# Access Compliance Report

## Public Rights-of-Way

Intersection ID: 28155	Main Street: WAYLAND_DR	Cross Street: ROBSART_CT	Location: SW
ADA ID: 64DECB64A66B	Ramp Type: PerpDiag	Initial Pass/Fail: Fail	Overall Compliance: No
		Severity Score: 12.5

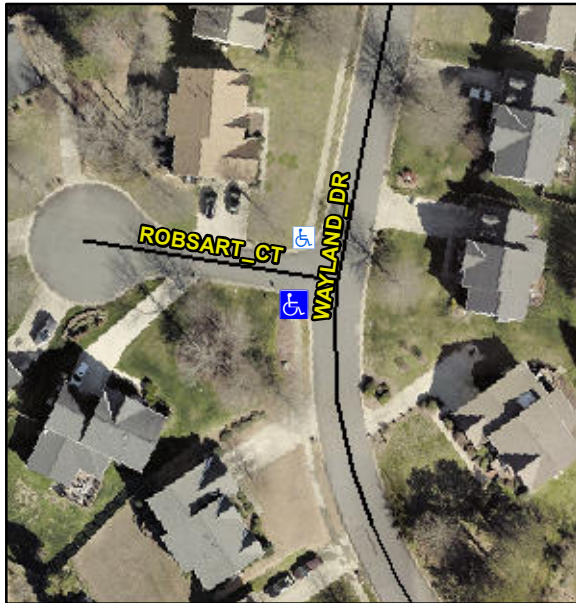
**Not Found, R304.2.2**

Compliance	Description	Data	Compliance	Description	Data
N/A	Ramp Length (in)	57.0	No	Ramp Slope (%)	8.9
Yes	Ramp Width (in)	48.0	Yes	Ramp XSlope (%)	1.2
N/A	Flare Type LT	N/A	N/A	Flare Type RT	N/A
N/A	Flare Slope LT (%)	N/A	N/A	Flare Slope RT (%)	N/A
N/A	Flare Traversable LT?	N/A	N/A	Flare Traversable RT?	N/A
N/A	Landing Length (in)	N/A	N/A	DWS Provided?	N/A
N/A	Landing Width (in)	N/A	N/A	DWS Contrast?	N/A
N/A	Landing Slope (%)	N/A	N/A	DWS Length (in)	N/A
N/A	Landing X Slope (%)	N/A	N/A	DWS Full Width?	N/A
N/A	Landing Curb? (Y/N)	N/A	N/A	DWS Offset (in)	N/A
N/A	Shared Landing?	N/A			
N/A	Gutter Ponding?	N/A	N/A	Gutter Slope (%)	N/A
N/A	Gutter Lip Ht (in)	N/A	N/A	Gutter X Slope (%)	N/A
N/A	Painted X Walk1?	No	N/A	Painted X Walk2?	No
	X Walk 1 Direction	To E		X Walk 2 Direction	To N
N/A	X Walk 1 Width (in)	N/A	N/A	X Walk 2 Width (in)	N/A
	X Walk 1 Slope (%)	2.4		X Walk 2 Slope (%)	5.6
	X Walk 1 X Slope (%)	5.7		X Walk 2 X Slope (%)	2.9

**Remove & Replace Curb Ramp With Two New Directional Ramps or Equivalent.**
